CCC GLOBAL CONSENT TO DISCHARGE STORMWATER - CRC 160056/CRC 190445

**BEFORE THE CANTERBURY REGIONAL COUNCIL
UNDER THE Resource Management Act 1991
AND**

IN THE MATTER of application CRC190445 by the
Christchurch City Council for a
comprehensive resource consent to
discharge stormwater from within the
Christchurch City area and Banks
Peninsula settlements on or into
land, into water and into coastal
environments

Application: CRC 190445

Att 1. P

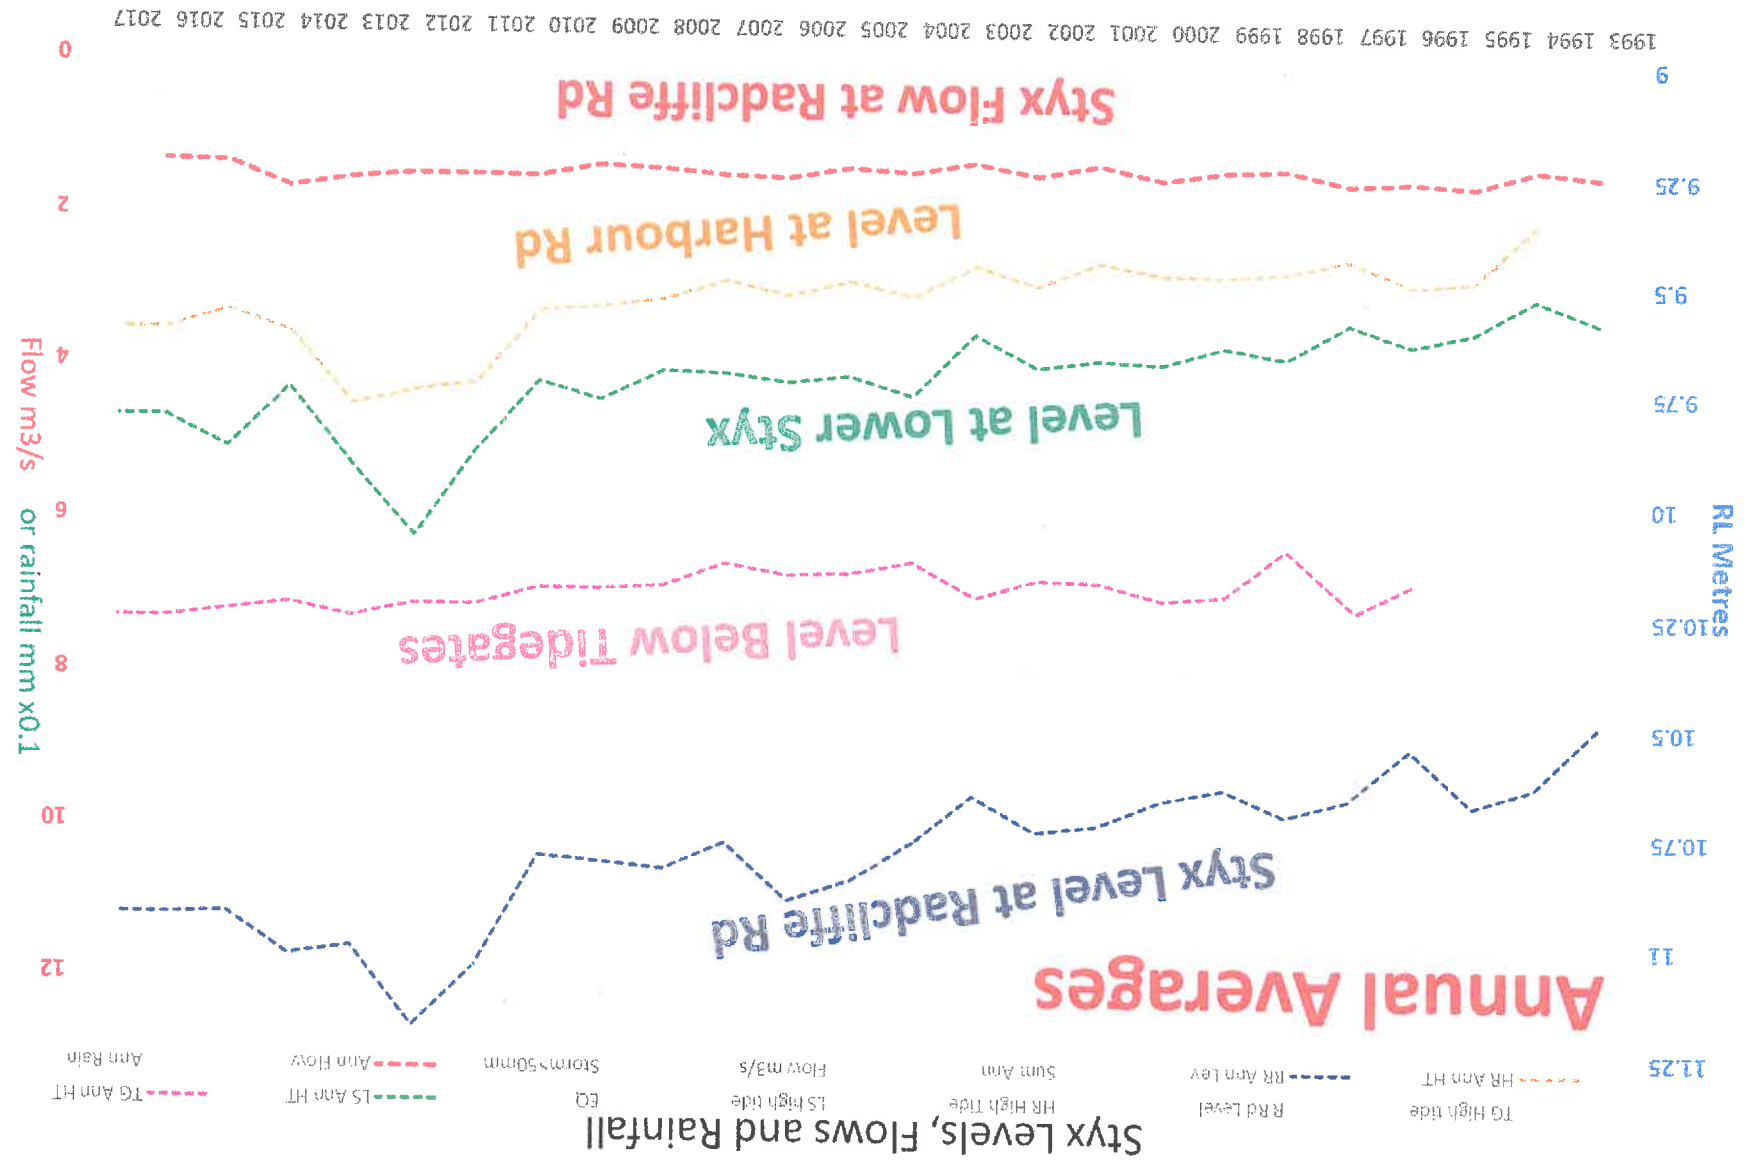
22. However a 'cumulative' effect on the water levels within the Styx River has been identified by CCC and formed part of a presentation to the 'Styx Working Party' by Graham Harrington. I wish to draw the panels attention to water levels as recorded at the Radcliffe Road site and presented by G. Harrington.(ATTMT 1)

23. I feel the data recorded at the Radcliffe Road site gives a good example of how the water levels have continued to rise within the rivers channel since 1993.. This site I believe gives the most accurate information on river levels - No inundation of private properties has occurred upstream and the site is not affected by the tides. .

ATT. 4

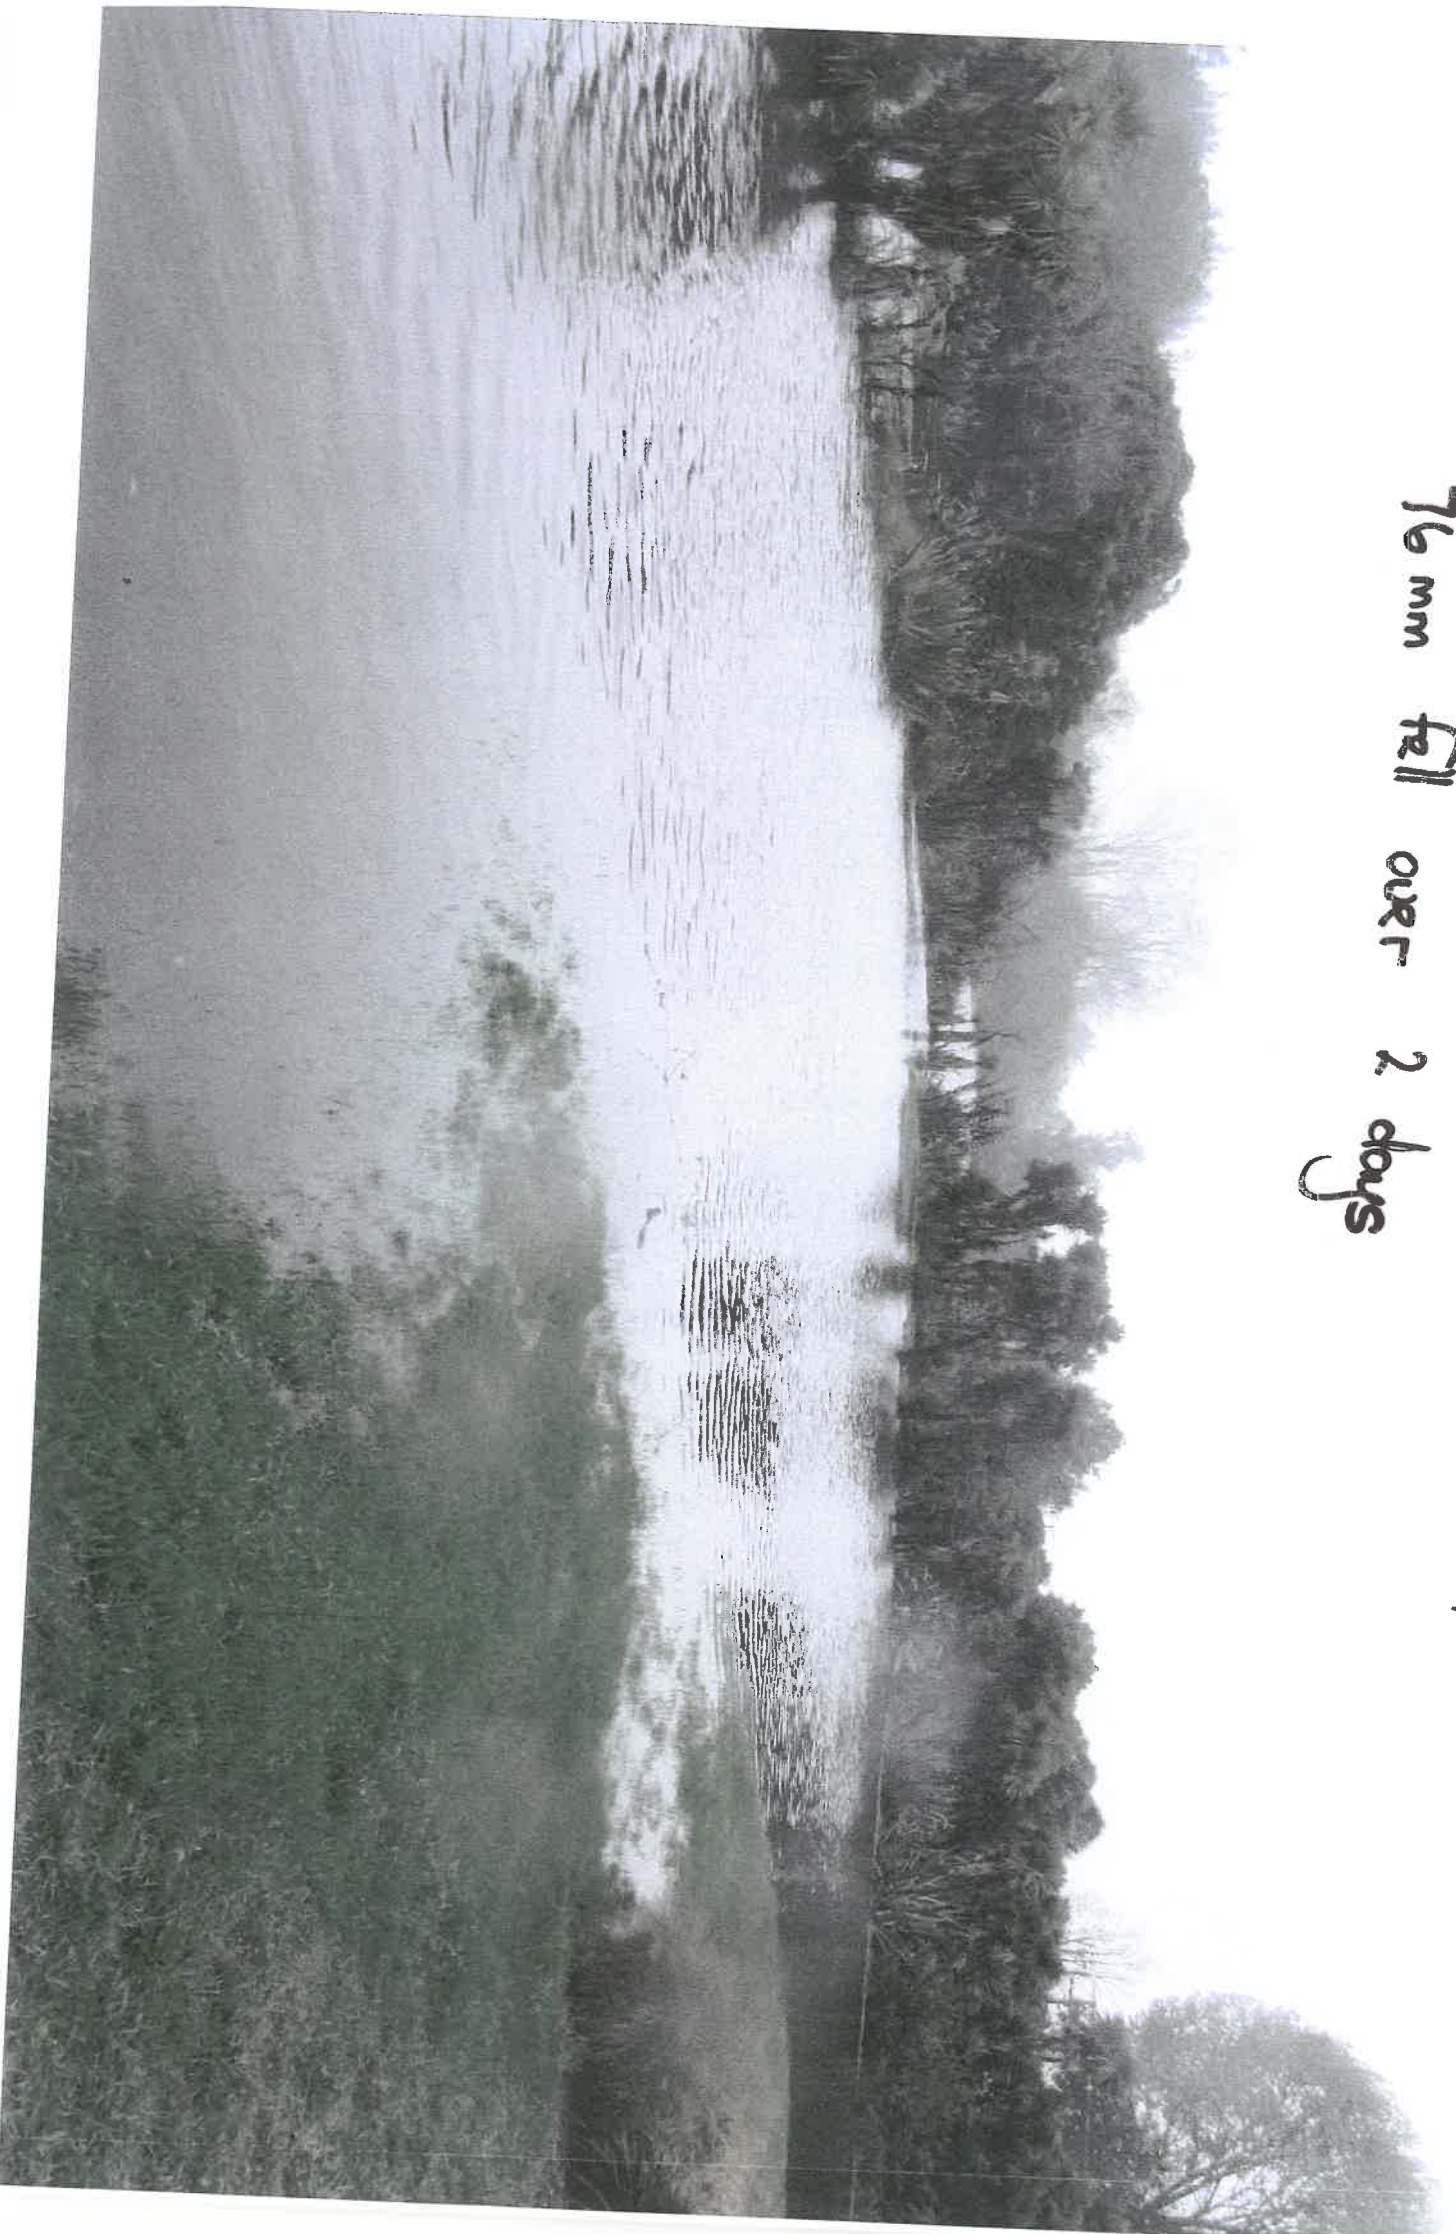
- 30. JANET STEWART RESERVE**
- 31. BEFORE – ATTMT 4- APRIL 2013; ATTMT 5 – APRIL 2014; ATTMT 6 – APRIL 2016 ; ATTMT 7 – APRIL 2018 ATTMT 10 – PHOTO MANAGEMENT PLAN OCT 2012**

- 32. AFTER – ATTMT 8 – NOVEMBER 2018**
33. I have corresponded rain events as measured by NIWA on the paper attachments.
34. I do accept this inundation does not pose an acceptable adverse effect to the community however the photos confirm the lower bench seat on the jetty in the Janet Stewart Reserve has been under water on many occasions and in 'minor' rain events.

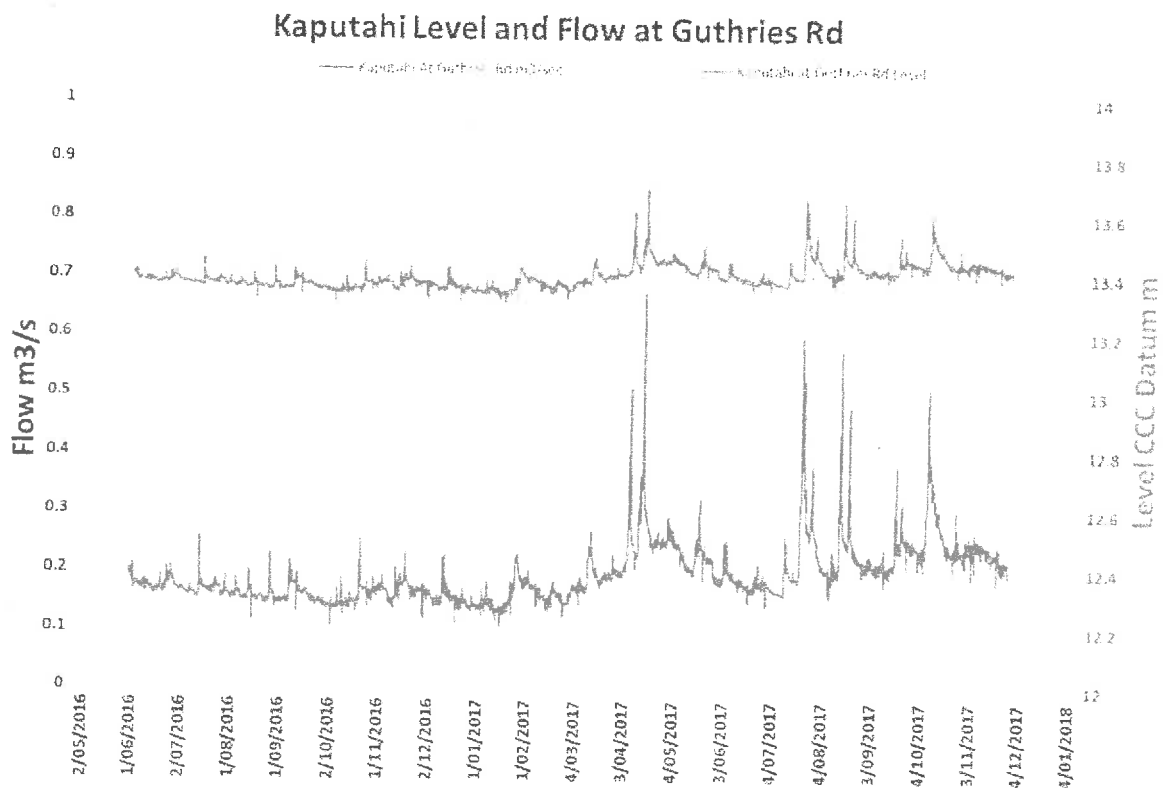
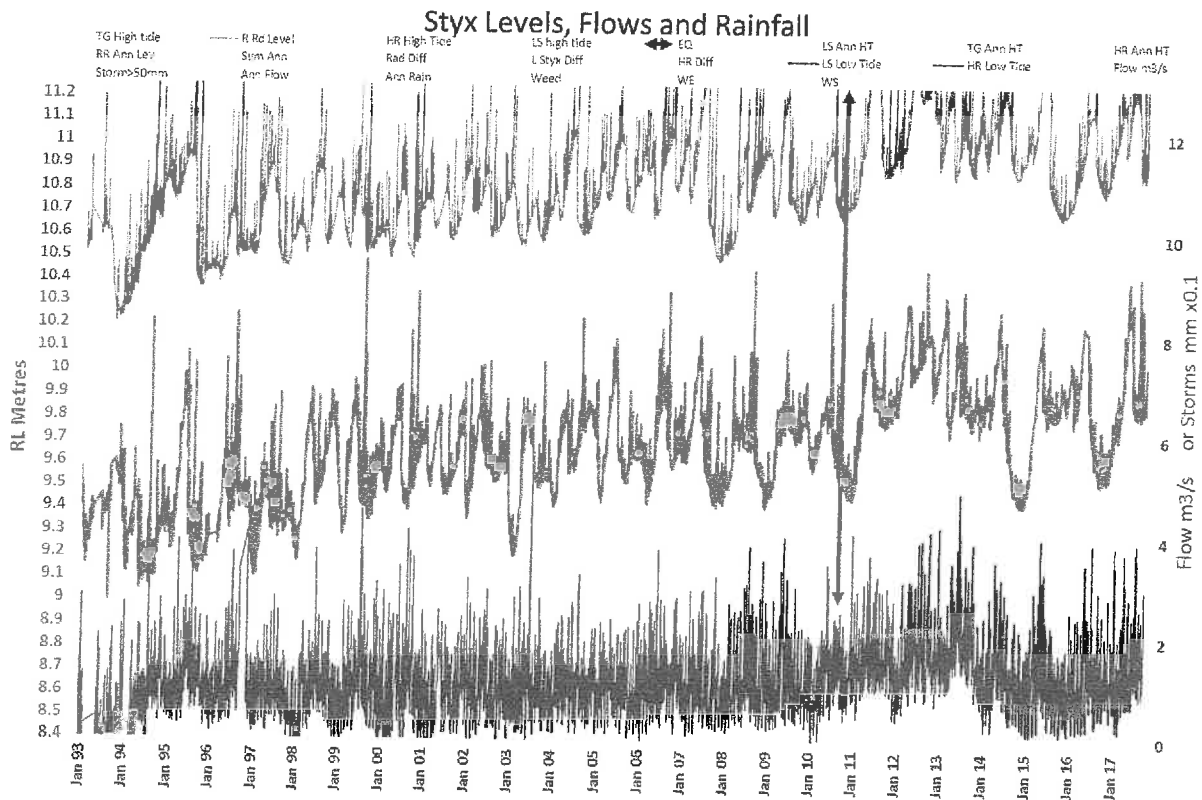
I have had a look at the low tide levels at Harbour Rd to see if there is an issue of draining the water from the lower reaches out through the tide gates - see attached pdf document. The Harbour Rd low tide level shows the same post-earthquake blip that the other sites above the tide gates show - but otherwise there does not seem to be any significant trend.

Up to now we have looked at the effectiveness of weed harvesting in reducing the water levels however - if you look at the effect of seasonal weed dieback you can see that it can reduce the Lower Styx level by up to 800mm. This is an effect which is independent of sediment, channel width or other physical restrictions in the channel that might be addressed by dredging. The dieback effect is also much greater than produced by mechanical weed harvesting. It does suggest that the single biggest factor restricting flow - and raising water levels - is the growth of weed and that other work to remove physical restrictions and sediment will have a relatively minor benefit.

I have also included (below) the flow record to date from Guthries Rd - as discussed on the field trip.
